**APPLICATION FOR
HISTORIC AREA WORK PERMIT**
HISTORIC PRESERVATION COMMISSION
301.563.3400

Building Number: 10305 Street: ARMORY AVENUE
Town/City: KENSINGTON Nearest Cross Street: BALTIMORE ST
Lot: 8 Block: 9 Subdivision: 0015 Parcel: _____

10305 ARMORY AVE HAWP PRELIM SUBMISSION

Please find attached response to staff comments provided on April 9, 2024

2
A103 PROPOSED SIDE ELEVATION
3/16" = 1'-0"

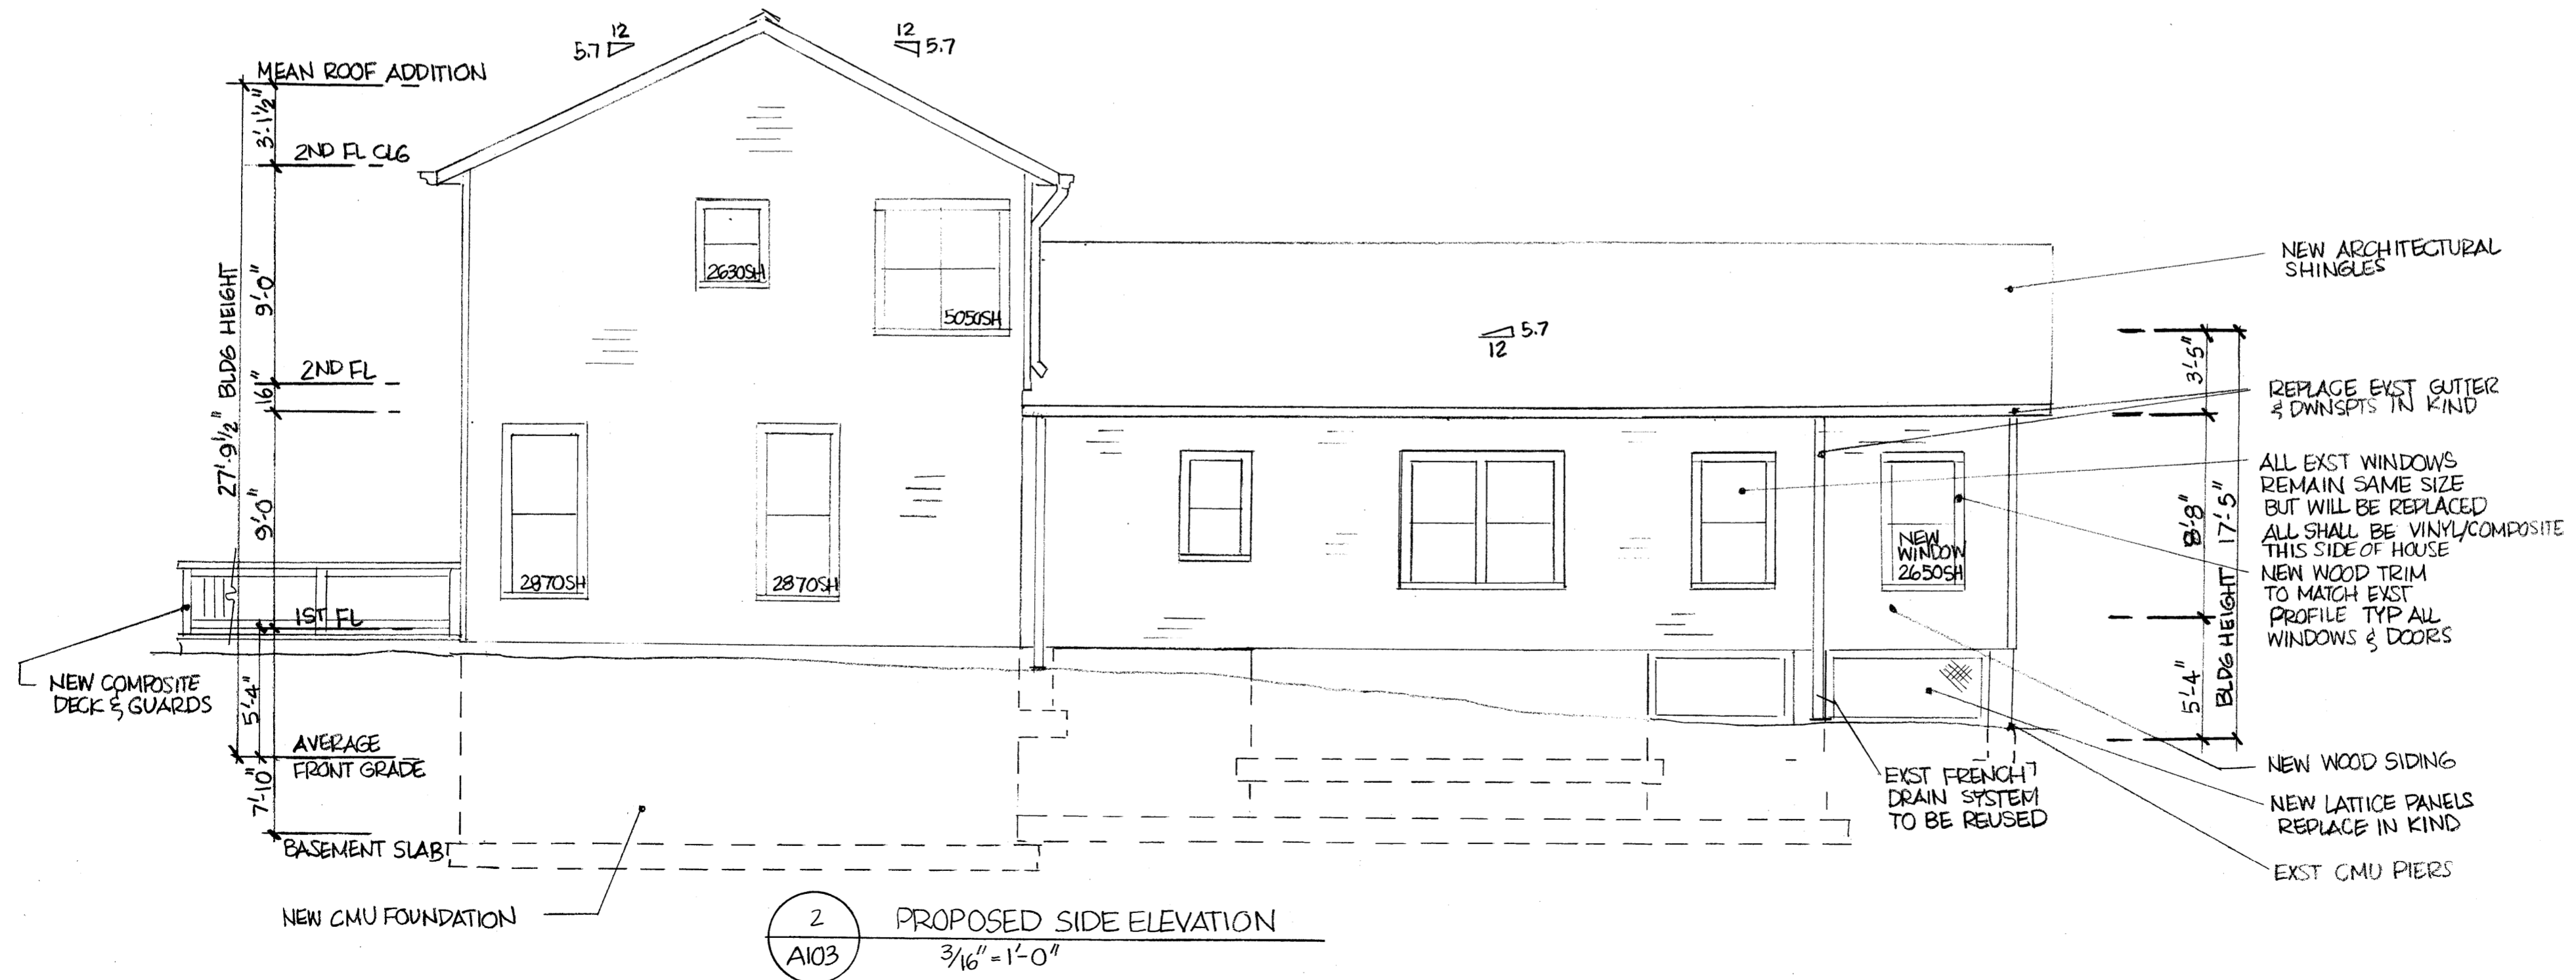
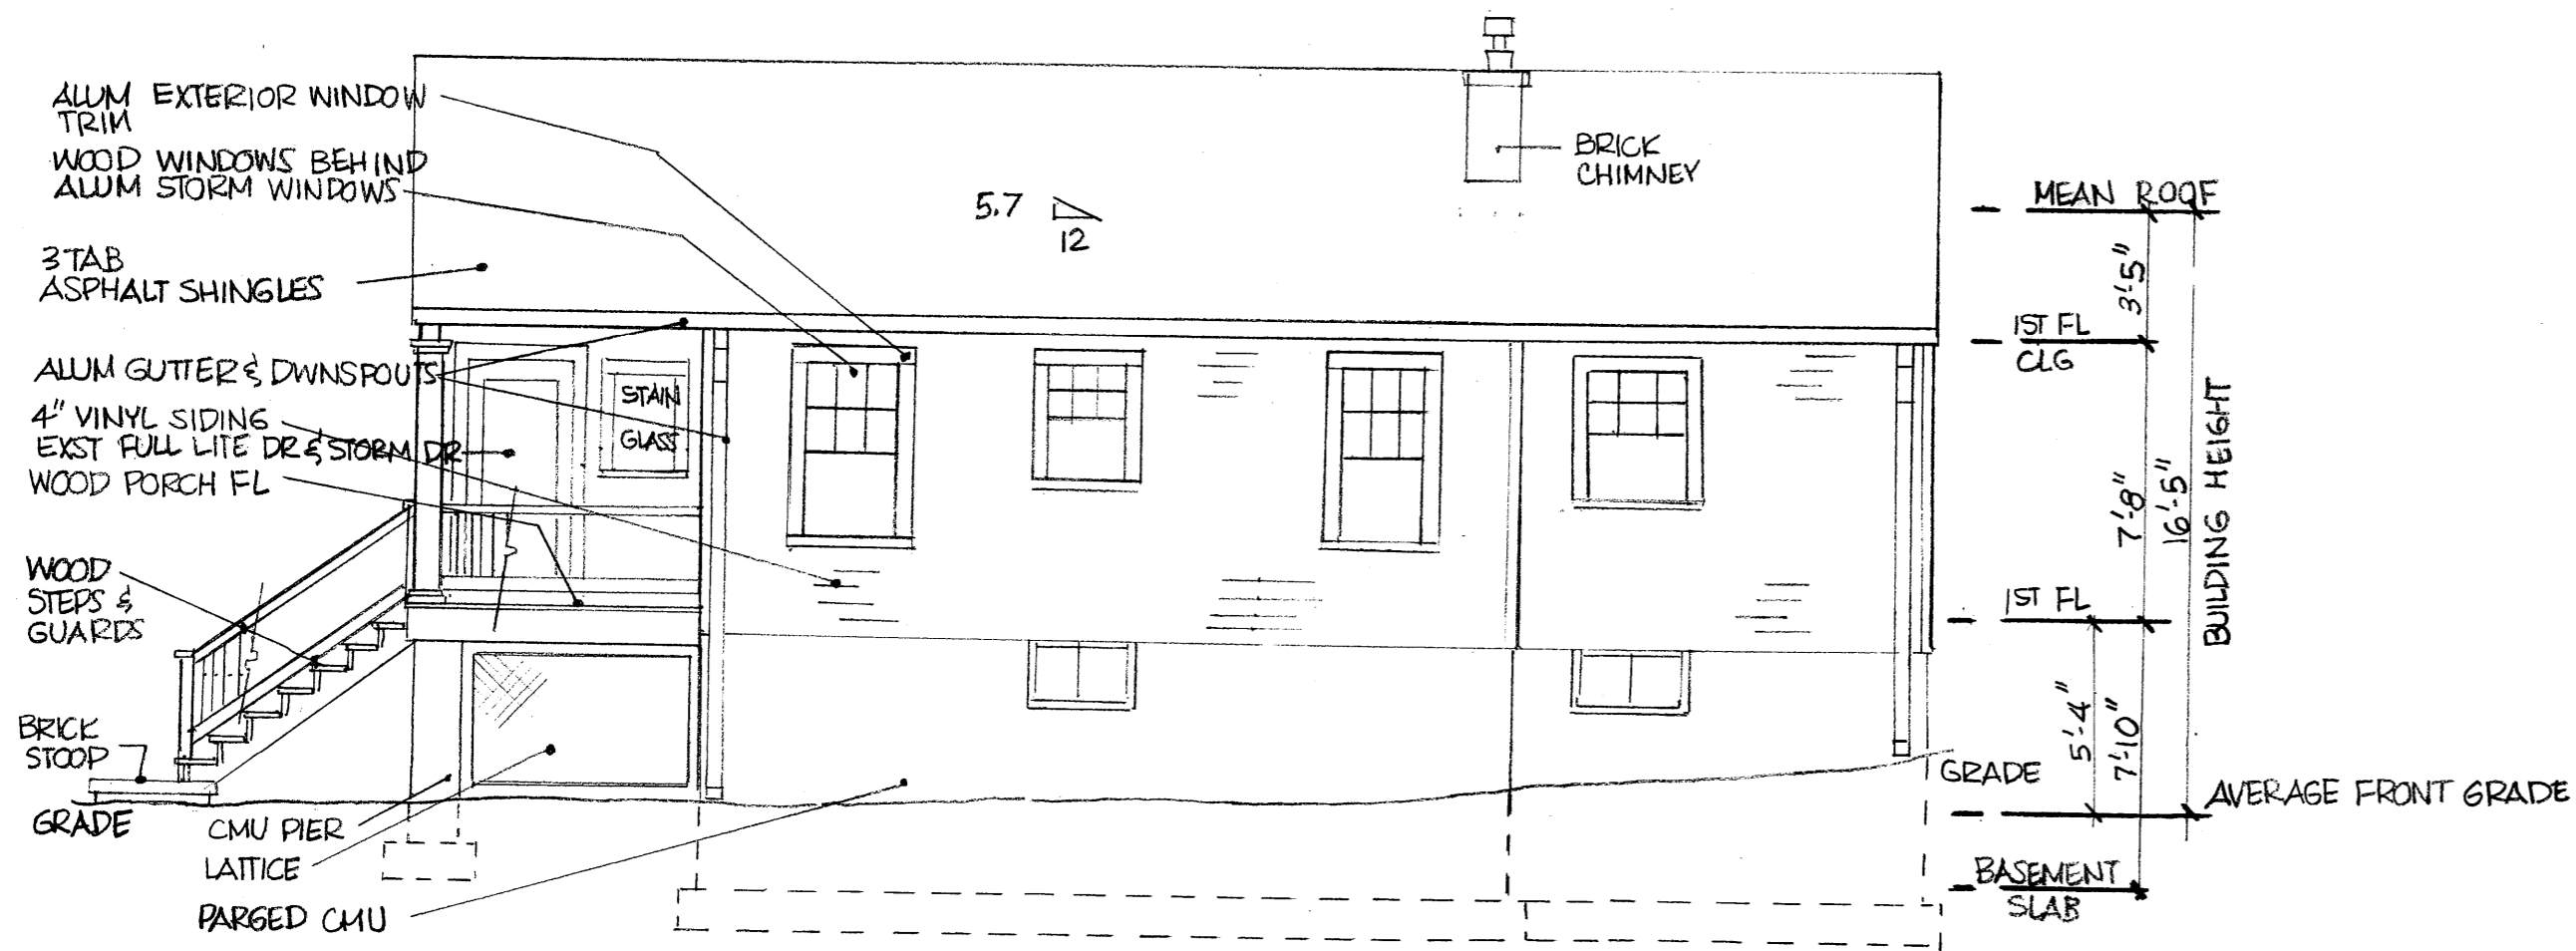
- Consider additional windows on the upper levels of the side elevations on the addition. [ONE WINDOW ADDED ON NORTH 2ND FLOOR SIDE](#)
- Consider retention of the brick chimney. [OWNER/CONTRACTOR STILL HOPES TO BE ABLE TO REMOVE CHIMNEY](#)
